Route 23 Connect Public Comment Map Summary

PID 112768 | U.S. 23 Corridor Study

Segment 1: I-270 to Olentangy Meadows Drive (45 Comments)

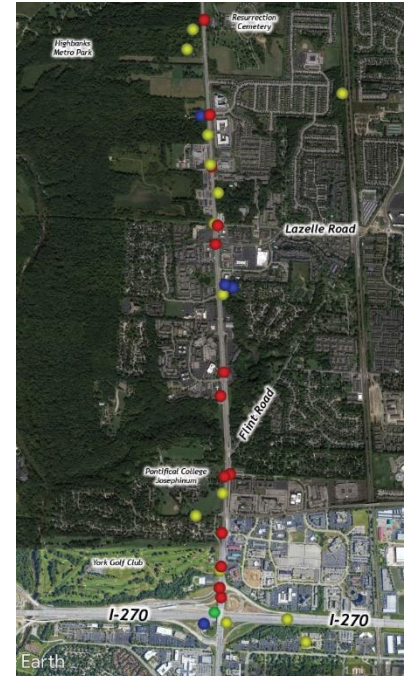
- **Congestion (Top Theme - 19 comments)**
 - Traffic needs to be directed away from/around U.S. 23/I-270 interchange
 - Too many traffic signals/traffic signals too close together
 - Too many access points (entrances/exits) to U.S. 23, left turn movements should be limited
- **Safety Concerns (16 comments)**
 - Lane/exit signage for southbound U.S. 23 towards I-270 is insufficient and diagonal arrows are confusing, causes people to switch lanes at the last minute, crashes
 - Traffic signal so close to I-270 off-ramp causes rear end crashes
- **Improvements Needed (8 comments)**
 - Better signage/pavement painting is needed on U.S. 23 southbound at I-270/SR 315/U.S. 23 interchange area
 - Add ramp directly from U.S. 23 northbound to I-270 E to avoid traffic from SR 315
 - Pedestrian improvements/facilities needed in area

Segment 2: Green Meadows Drive to Orange Road (102 Comments)

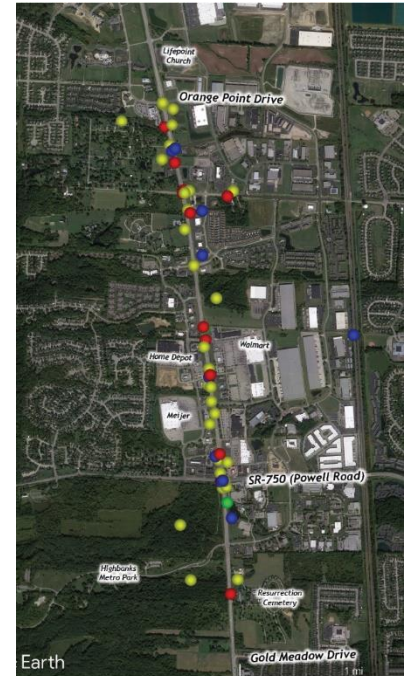
- **Congestion (Top Theme - 44 comments)**
 - Heavy congestion during peak hours
 - Too many traffic signals/traffic signals too close together
 - Too many access points (entrances/exits) to U.S. 23
 - Frontage roads/thru traffic bypass lanes needed
 - Traffic signal timing needs to be improved
- **Safety Concerns (24 comments)**
 - Lots of people running red lights
 - Speed limit too high
 - Light cycles too short, not enough buffer time between light changes
 - U.S. 23 roadway curvature at Orange Road causes visibility issues
- **Improvements Needed (20 comments)**
 - Frontage roads
 - Limit access/entry points to U.S. 23
 - Pedestrian accommodations

Segment 3: Orange Point Drive to Olentangy Crossing (62 Comments)

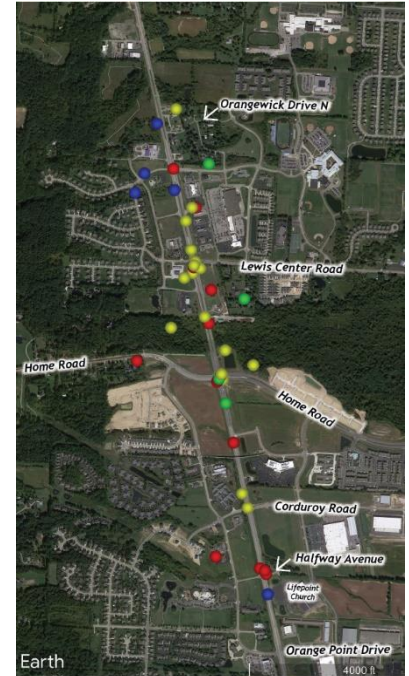
- **Congestion (Top Theme - 25 comments)**
 - Heavy congestion during peak hours near Lewis Center Road and Home Road
 - Too many traffic signals/traffic signals too close together
 - Too many access points (entrances/exits) to U.S. 23
 - Semi-trucks slow traffic
- **Safety Concerns (16 comments)**
 - Too many drivers running red lights
 - Speed limit too high
 - Right-in/right-out not followed at Halfway Avenue, need to build up median to enforce
- **Improvements Needed (9 comments)**
 - Frontage roads
 - Limit access/entry points to U.S. 23
 - Pedestrian accommodations needed

Segment 4: Hyatts Road/Shanahan Road to Pollock Road (54 Comments)

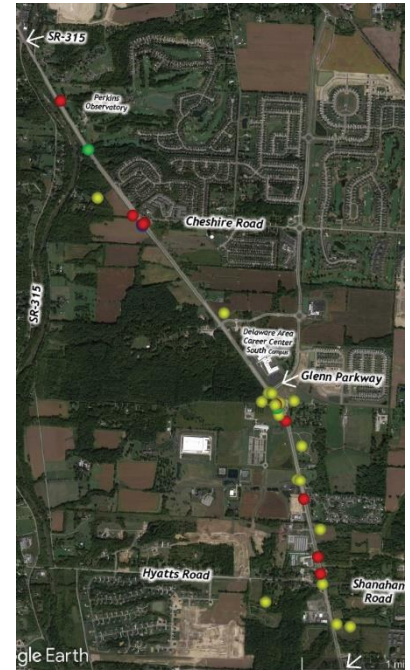
- **Congestion (Top Theme - 20 comments)**
 - Heavy congestion at Glenn Parkway
 - Heavy congestion during peak hours
 - Too many traffic signals/traffic signals too close together
- **Safety Concern (12 comments)**
 - Drivers on U.S. 23 run red lights at Cheshire Road intersection creating very dangerous situation
 - Pollock Road intersection is dangerous (should have limited access/intersection improvements)
- **Improvements Needed (9 comments)**
 - Frontage roads
 - Light for left turn lane onto U.S. 23 southbound at Glenn Parkway needs to be longer, or additional left turn lane needed to allow more cars

Segment 5: SR 315 to U.S. 42 (45 Comments)

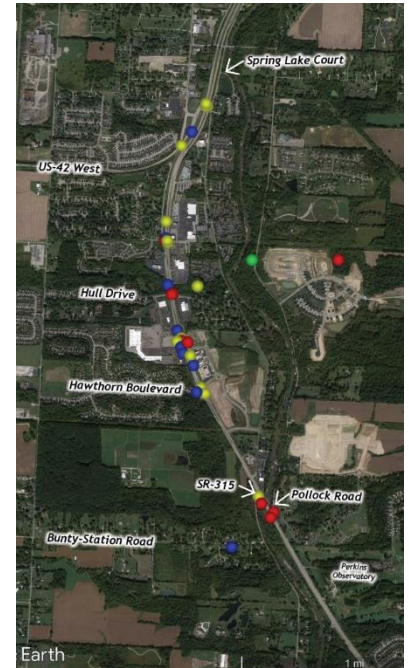
- **Congestion (Top Theme - 17 comments)**
 - Too many traffic signals/traffic signals too close together
 - Traffic signals do not seem coordinated
- Improvements Needed (13 comments)
 - Limit access/entry points to U.S. 23
 - Upgrade/re-work U.S. 42 and U.S. 23 intersection area
 - Frontage roads
- Safety Concerns (12 comments)
 - Left turn from Hull Drive onto U.S. 23 south is dangerous

City of Delaware: Between Segments 5 and 6 (49 Comments)

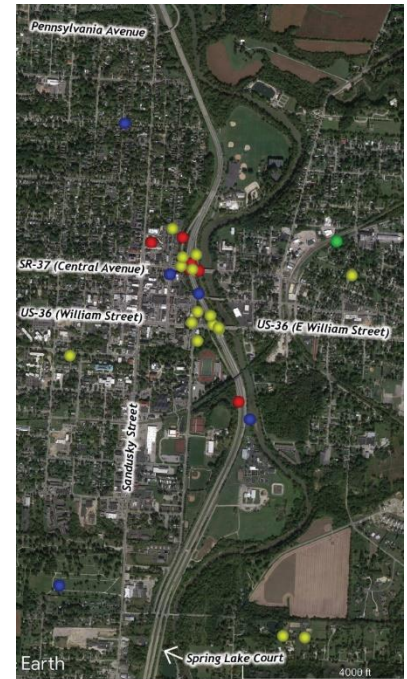
- **Congestion (Top Theme - 21 comments)**
 - U.S. 36 (William Street) area has severe congestion
 - SR 37 (Central Avenue) area has severe congestion
- Improvements Needed (15 comments)
 - Northbound on-ramp connection at SR 37 (William Street) and U.S. 23
 - Lighting and beautification needed under overpass to help connect downtown with the riverfront district
- Safety Concern (7 comments)
 - Prioritize and improve pedestrian and bike facilities at U.S. 23 and SR 37 (Central Avenue)

Segment 6: Pennsylvania Avenue to Coover Road (59 Comments)

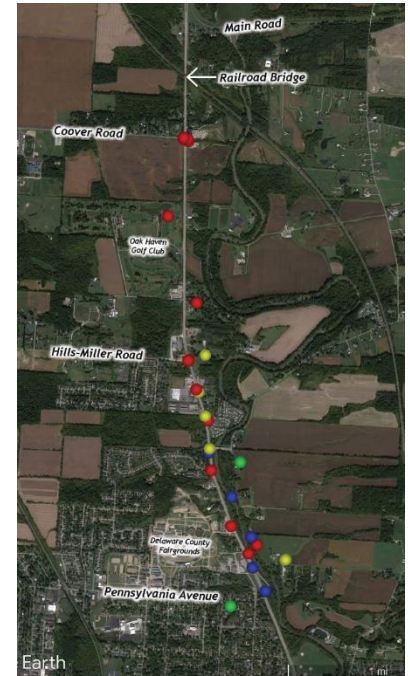
- **Safety Concerns (Top Theme - 27 comments)**
 - Intersection of U.S. 23 and Coover Road
 - Overgrown trees cause poor visibility on Coover road looking at southbound U.S. 23 traffic
 - Heavy usage by Buckeye Valley students and busses at peak times, new drivers navigating intersection
 - Intersection of U.S. 23 and Hills-Miller Road is dangerous
 - Too many access points (entrances/exits) to U.S. 23
- **Congestion (10 comments)**
 - Too many traffic signals/traffic signals too close together
 - Access out of Shroyer's Mobile Homes to U.S. 23 southbound difficult
- **Improvements Needed (13 comments)**
 - Frontage roads
 - Limit access/entry points to U.S. 23 and across U.S. 23
 - Pedestrian and cyclist accommodations needed to connect to nearby parks and trails
